**RE: ADDENDUM NO. 2
KENT COUNTY FAMILY COURT – BRICK WALK
STATE OF DELAWARE, PROJECT # 15062
BID # MC1002000316**

Project: State of Delaware – MC1002000316
Kent County Family Court Pavers
Project No.: 15062

State of Delaware - OMB/DFM
Kent County Family Court - Brick Walk
StudioJAED Project No. 15062
Bid & Construction

STATE OF DELAWARE
 OMBUDSMAN OF FACILITIES MANAGEMENT
 PROJECT
 KENT COUNTY FAMILY COURT - BRICK WALK
 400 COURT STREET
 DOVER, DE 19901

ISSUED FOR BID & CONSTRUCTION MARCH 4, 2016	
DRAWN HMS	CHKD/DESIGNER PRC
DISCIPLINE A	SHEET NO. 3.2
PROJECT NO. 15062

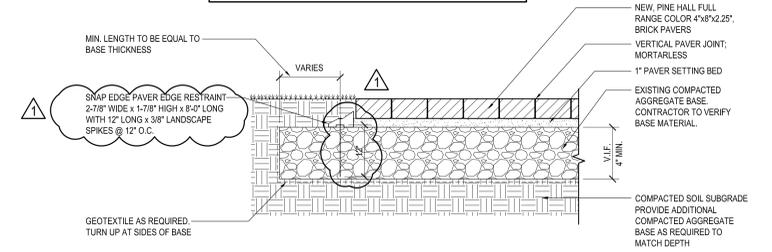
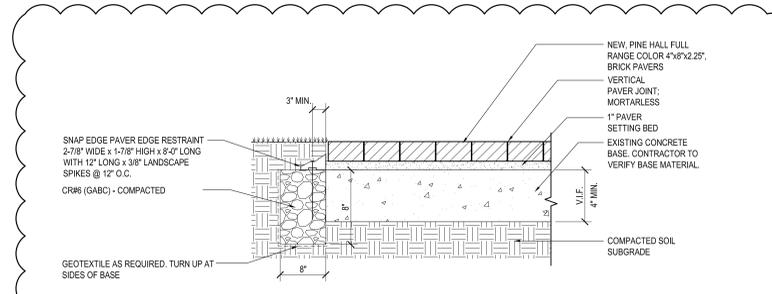
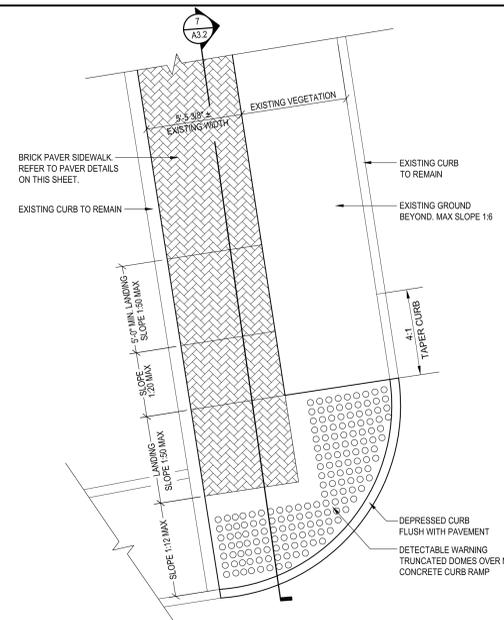
1. Please replace the existing drawing A 3.2 with the attached drawing A 3.2 to show clarifications and additions to the edge restrain details base on possible existing bases found under the existing pavers.

1 PAVER SECTION - CONCRETE BASE
 SCALE: 1 1/2" = 1'-0"

NOTE: CONTRACTOR TO VERIFY EXISTING BASE MATERIAL.

2 PAVER SECTION - AGGREGATE BASE
 SCALE: 1 1/2" = 1'-0"

10 PAVER SECTION - WHERE CONC. BASE DOES NOT EXTEND 5\"/>
